Service Bulletin

Subject: **QUICK SHIFT screw replacement**

Product: **F4 - F4 R - F4 RR - MY 2013**

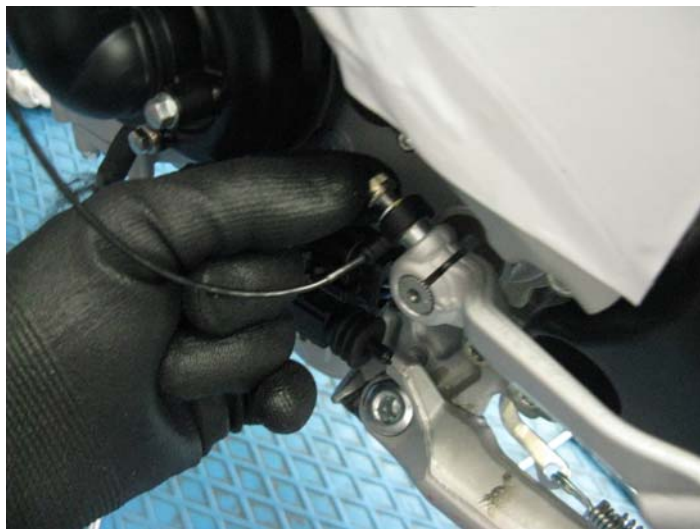
After a continuous product quality monitoring, we found a possible irregularity in the functioning of the EAS system, caused by an interference of the screw with the sensor, it is therefore necessary to replace the EAS sensor and shift lever fixing screw.

- remove the EAS sensor-shift lever fixing screw mounted on the motorcycle

- pick up the new screw part number 8000B8930

- insert the new screw in the EAS sensor, as shown in figure.

- Apply a layer of Loctite 243 thread lock in the first screw threads, taking care not to cover the EAS sensor area.

- Tighten the screw to a 7-8 Nm torque
